ADDENDUM No. 1

Date: May 8, 2024

Project: Roseburg Regional Airport
Taxiway A Extension

C-201

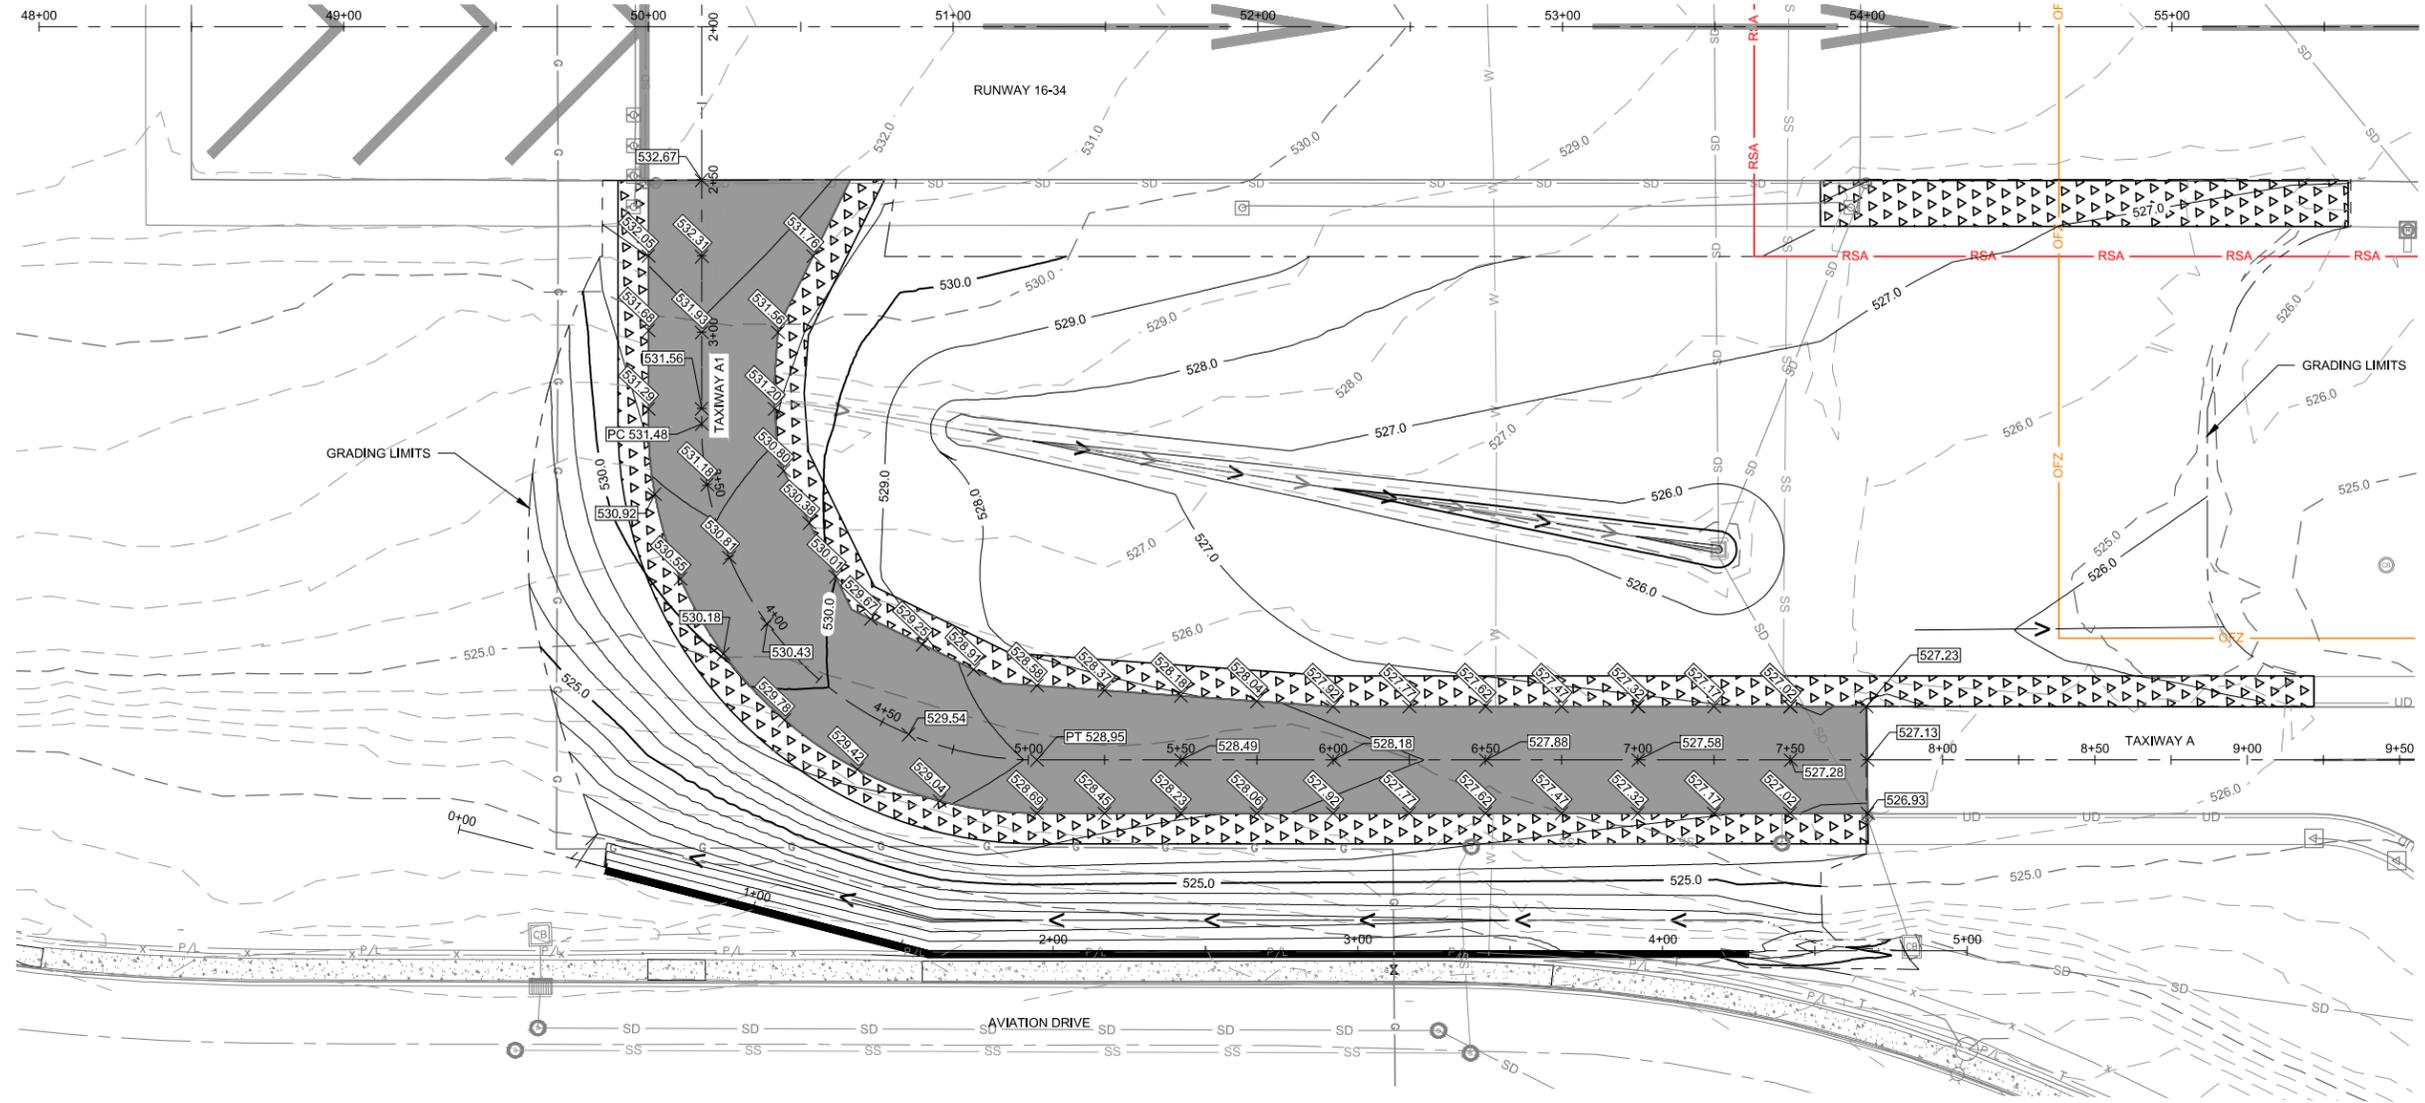
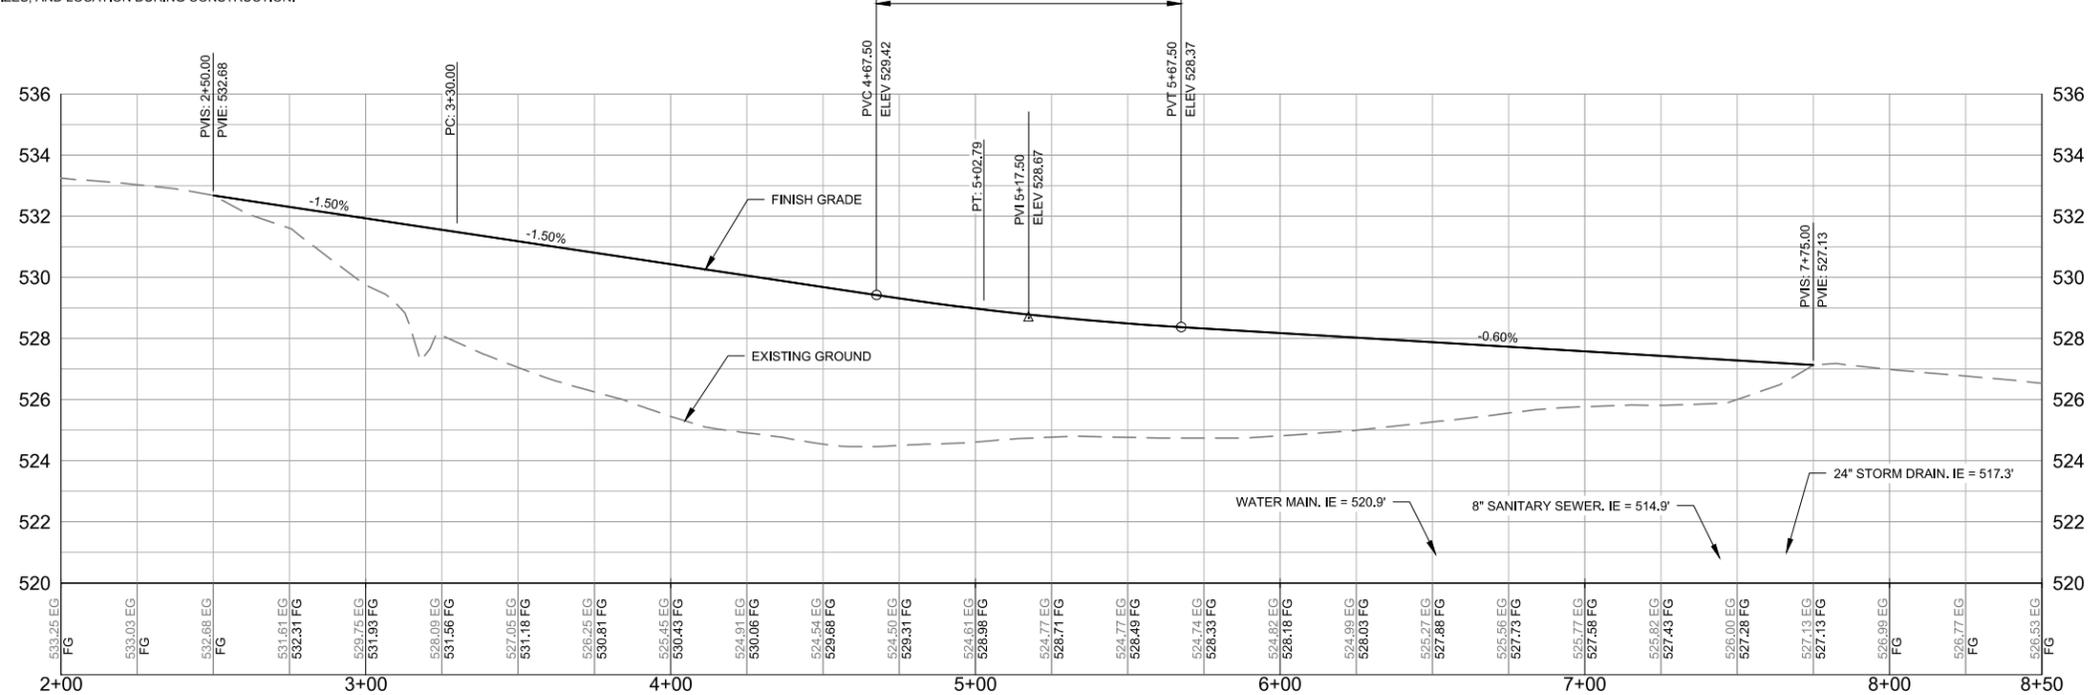
- Replace Sheet C-201 in its entirety with Sheet C-201 included under this addendum.
Clarification: Revised sheet shows existing contours within the new grading limits.

A: CAD Files will not be provided. The Grading plan will be revised to show additional contours, and provide the contractor with cut and fill info outside of pavement areas.
